**The Old House, 16 Station Road,
Littlethorpe, Leicestershire:
Historic Building Impact Assessment**

For: J & N Builders Ltd

DCI Architecture Ltd

ULAS Report Number 2008-034

client:
J & N Builders Ltd
drawing
Planning Drawing 2 of 2

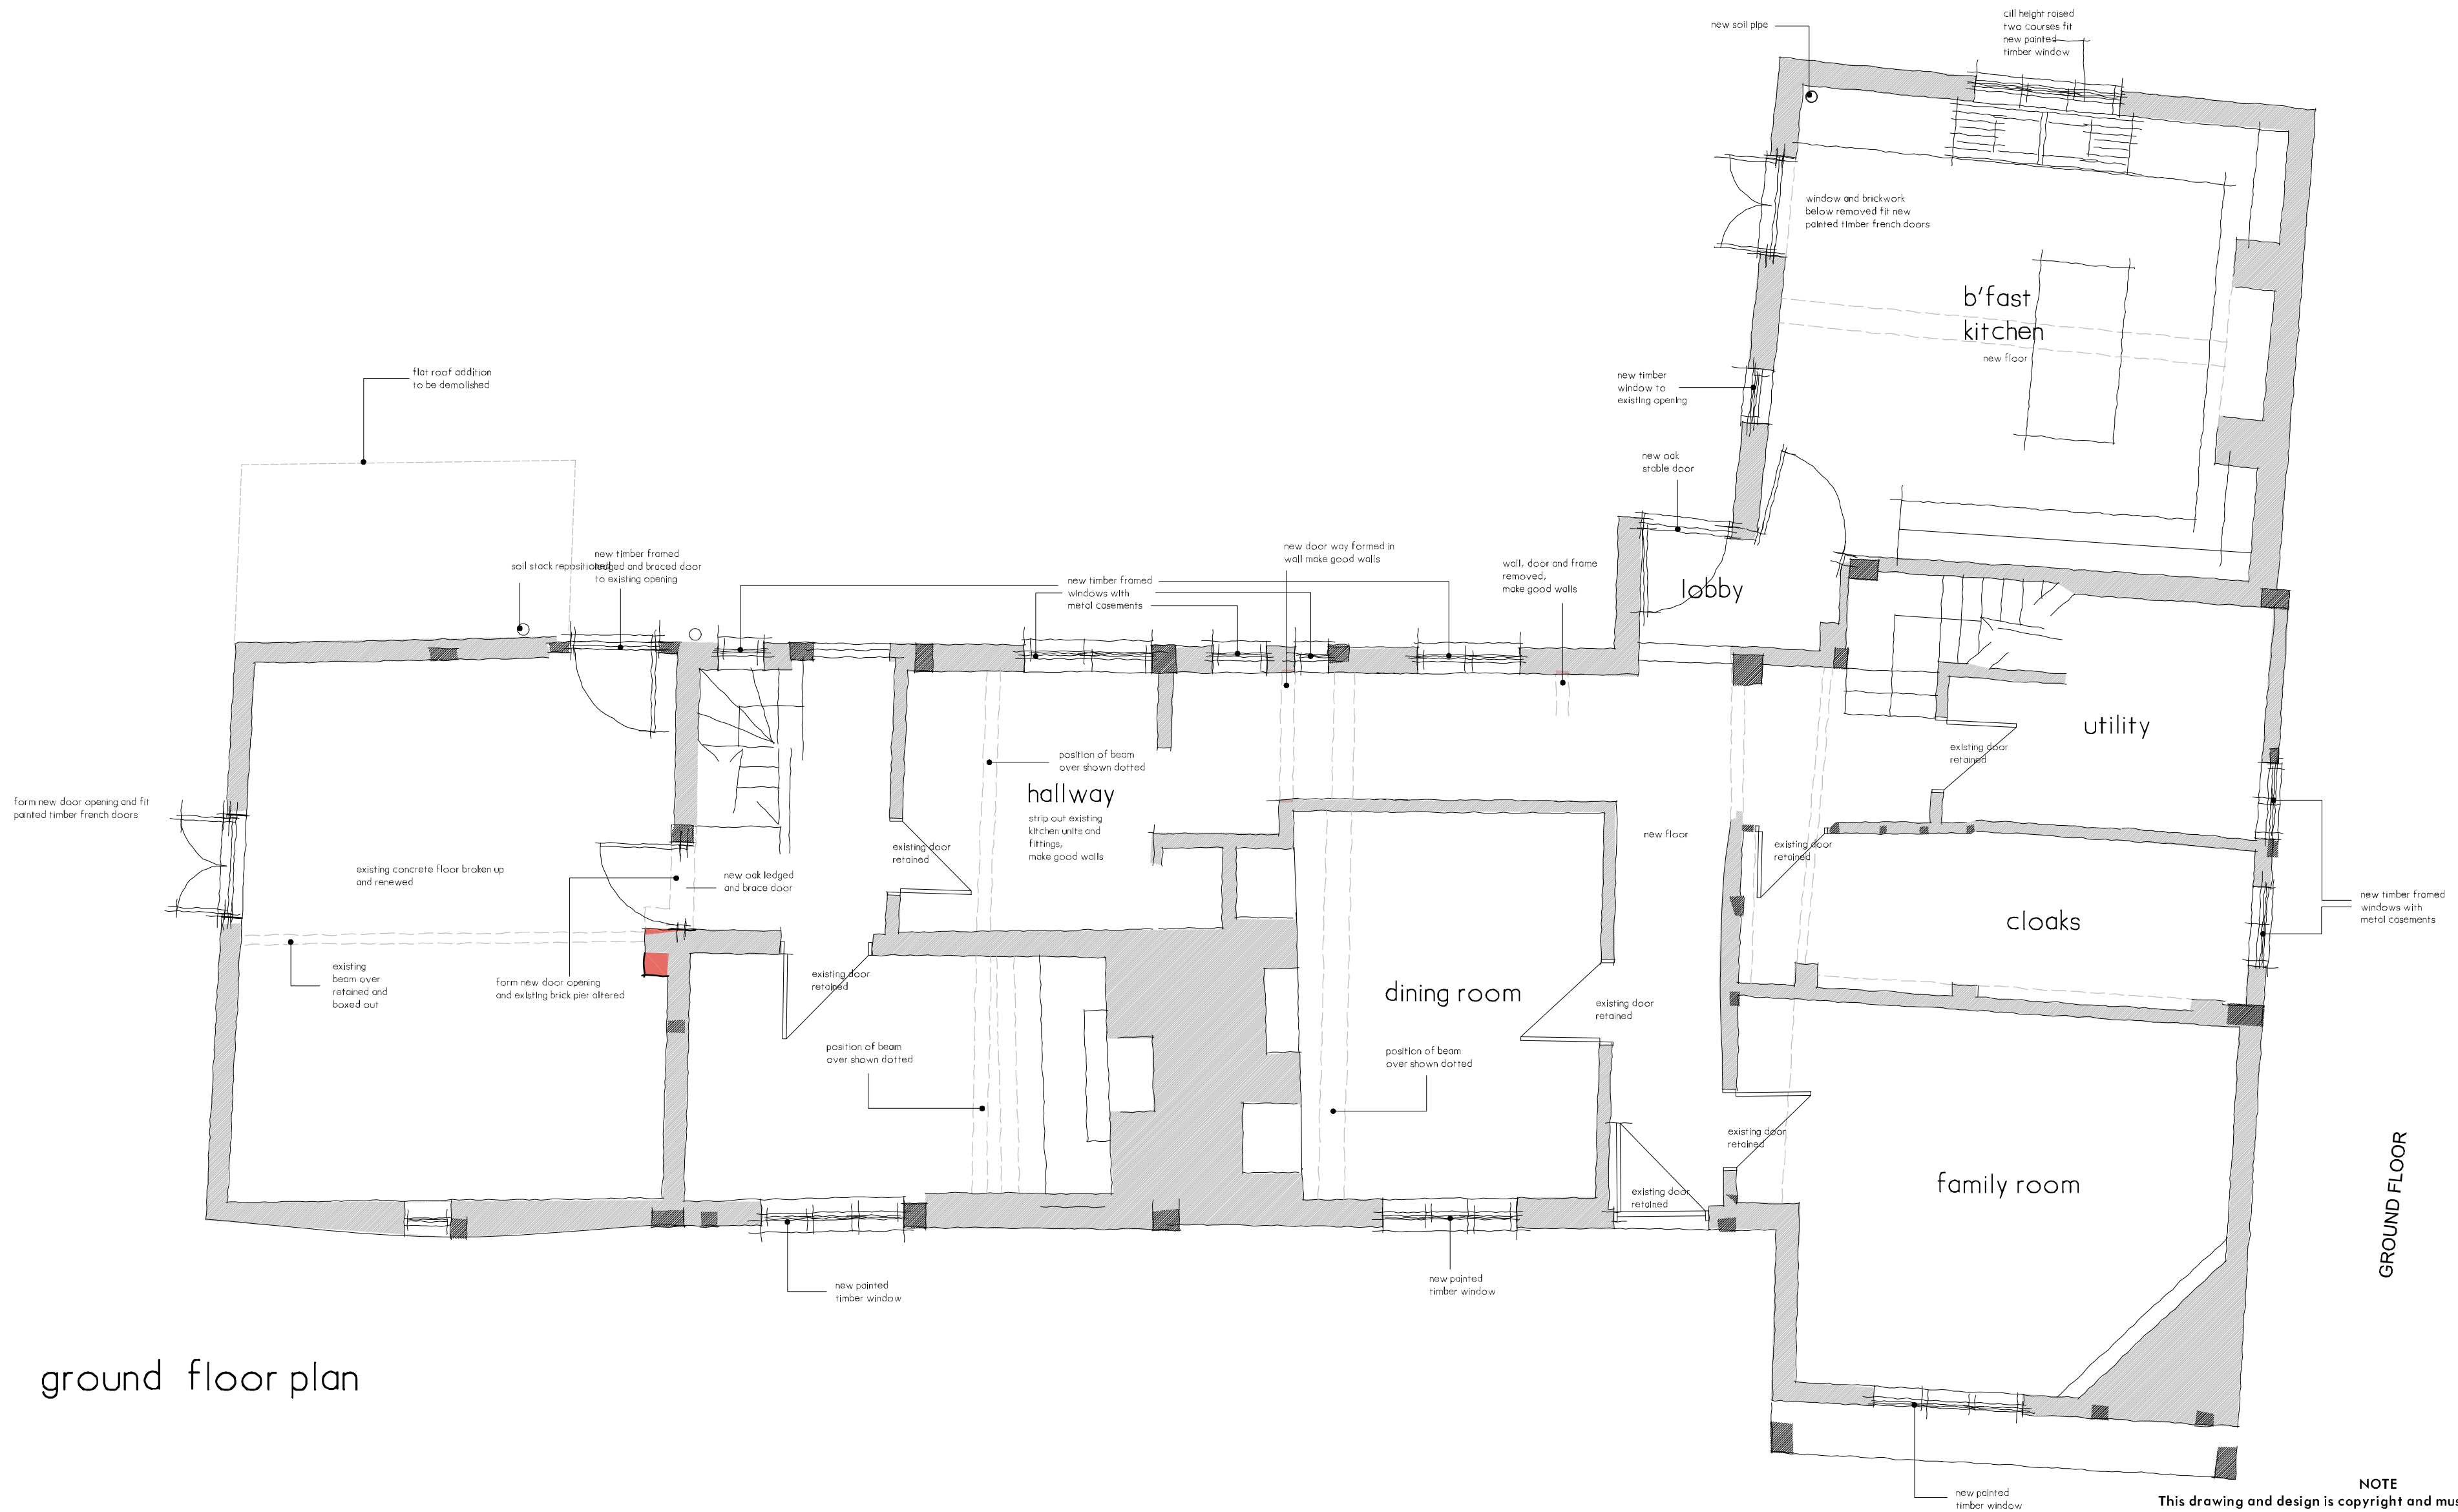
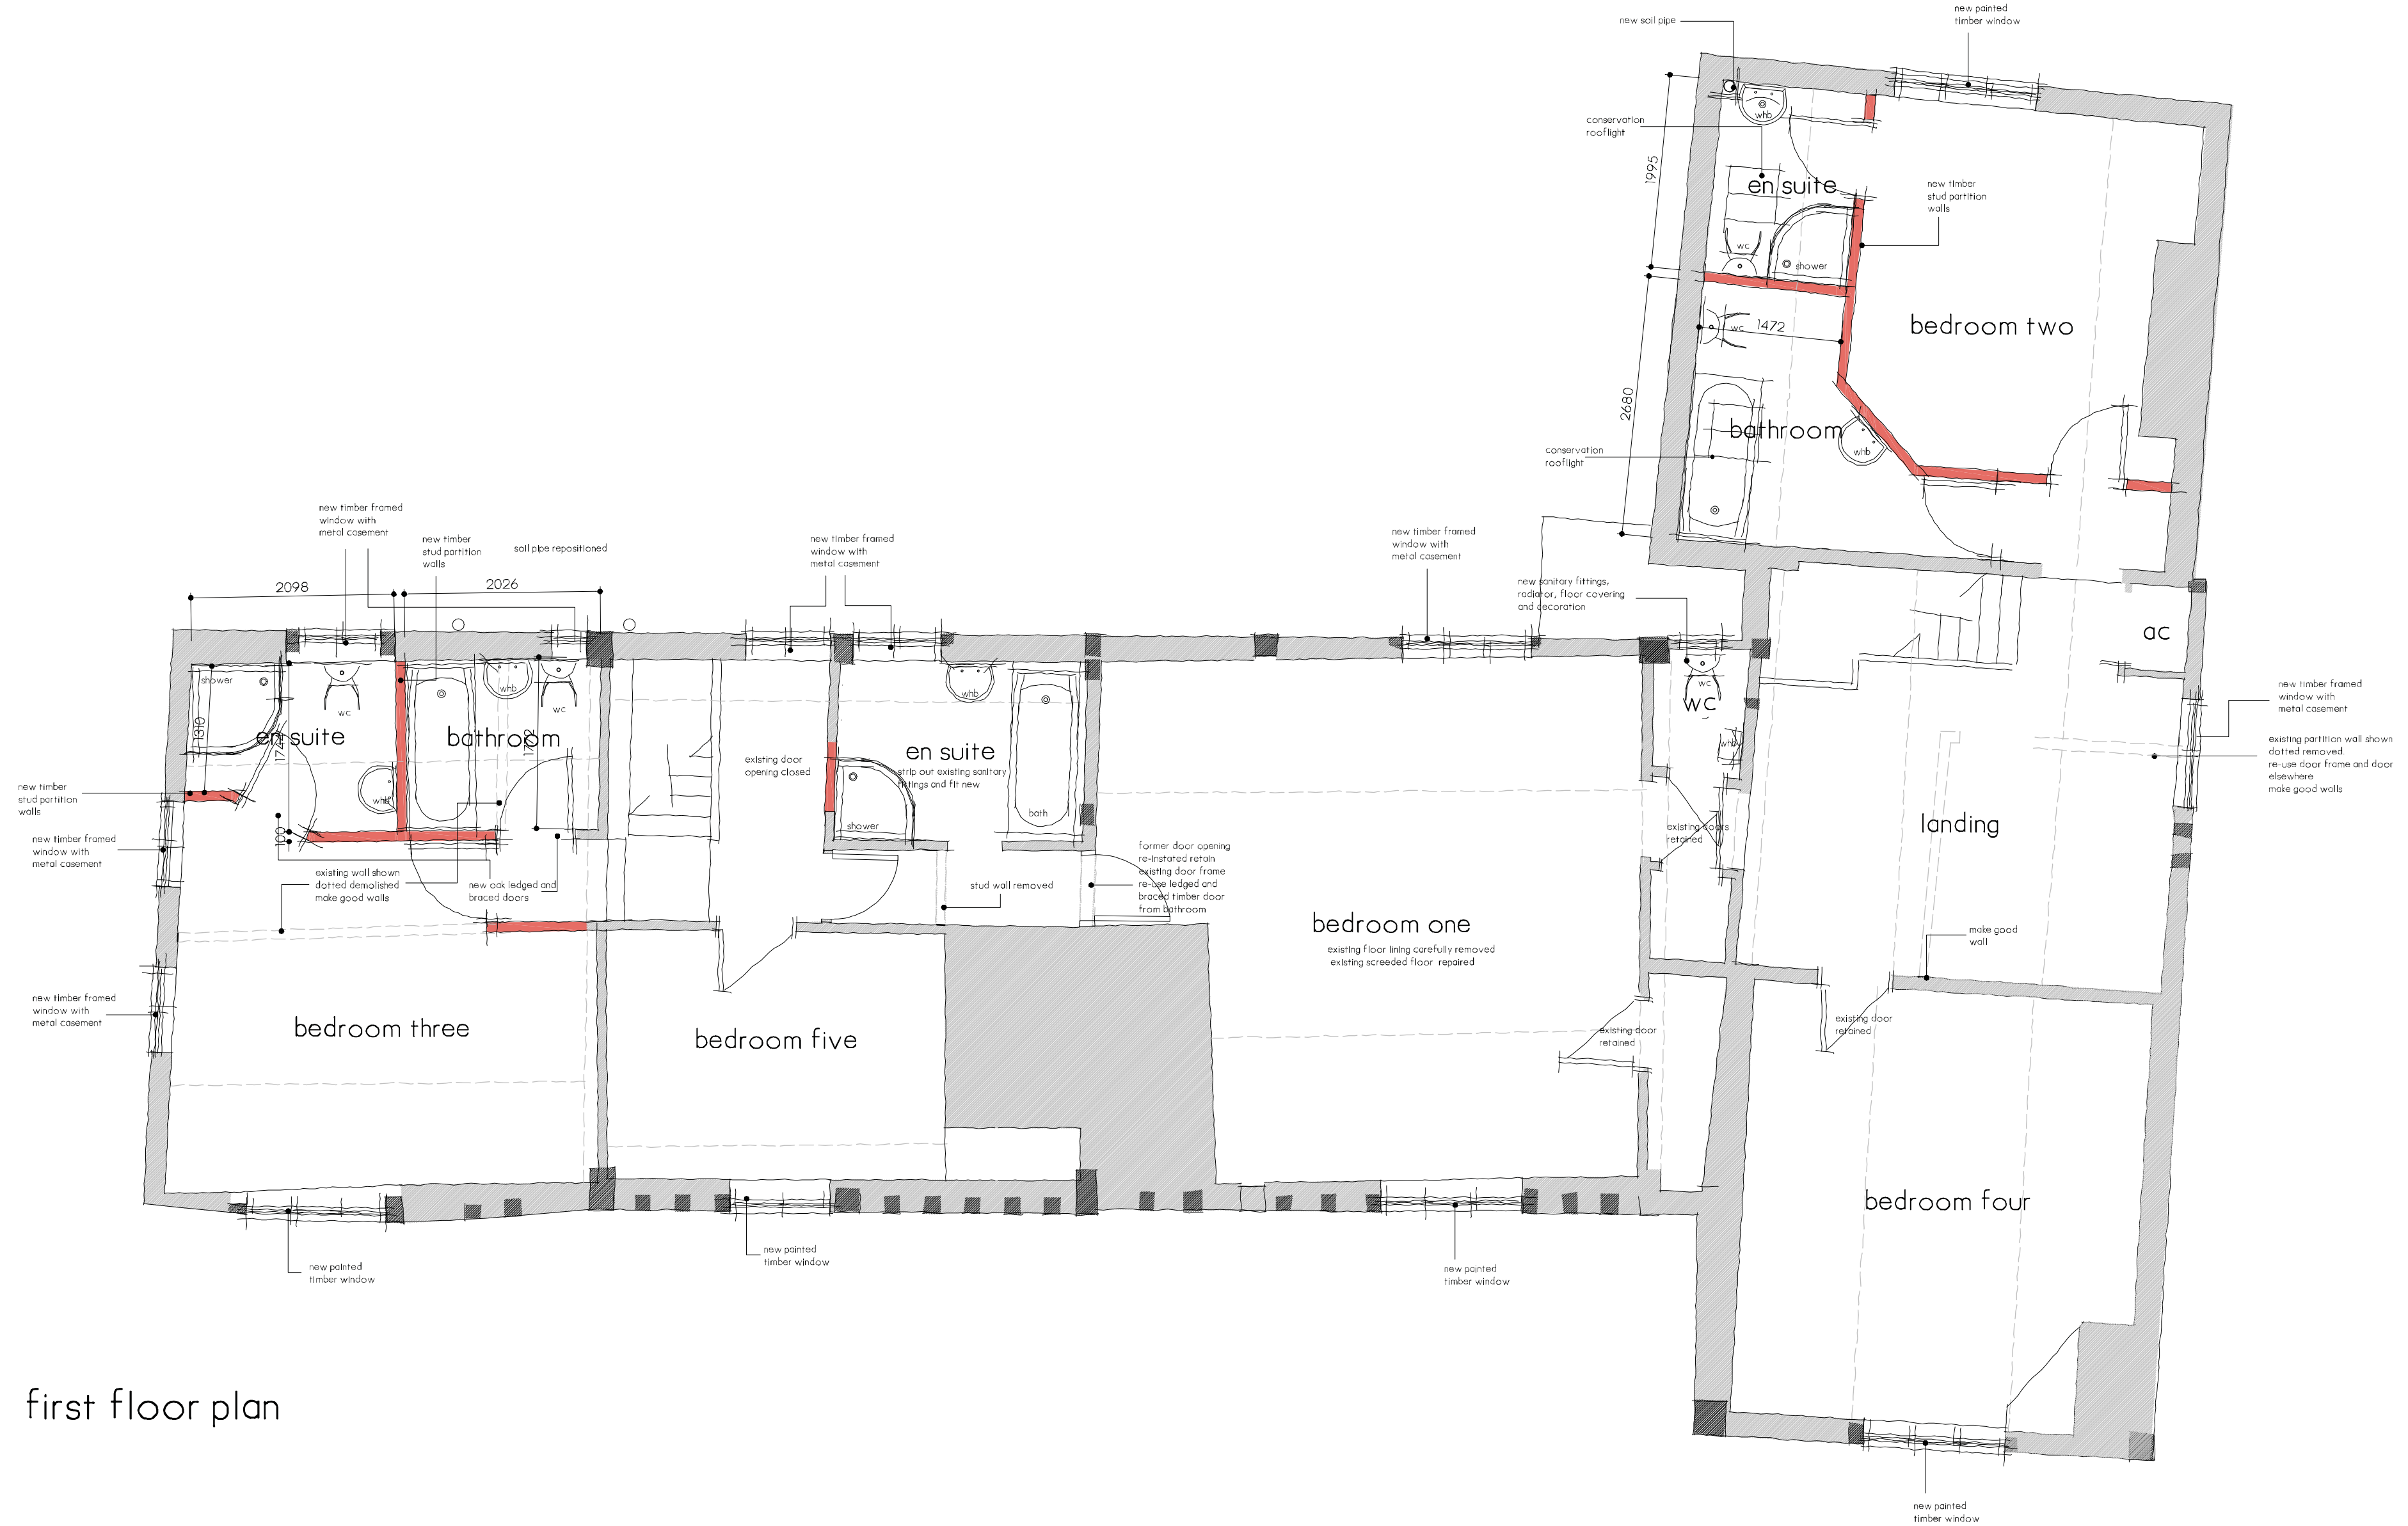
of the proposed new windows on the front (west) elevation would be painted timber, as would those on the east gable end of range C. Elsewhere timber frames with metal casements are proposed. Typically the fenestration of a building which has evolved over several centuries will be mixed, reflecting changing architectural styles and episodes of historic repair or renewal, and wholesale replacement of windows within a listed building would not normally be approved. In this instance the issue is complicated by the fact that all of the existing windows appear to date to the first half of the 20th century and are variable in terms of their architectural style and integrity, build quality and state of preservation. Conservation best practice would advocate repair of existing windows rather than replacement. In most if not all cases windows could be replaced without significant impact upon historic fabric, however the visual impact would be more significant, resulting in a homogeneity that would not be appropriate to the age and complexity of the building and which currently does not exist, despite the fact that all of the windows were replaced within a relatively short timespan in the early 20th century. A reasonable case could be made for replacing certain individual windows, for example the glass brick window in the front (west) elevation of range B. It is possible that the replacement of other individual windows might be considered, for example where a window of no intrinsic architectural or historical merit is in a particularly poor state of repair; any such proposals would require detailed justification.
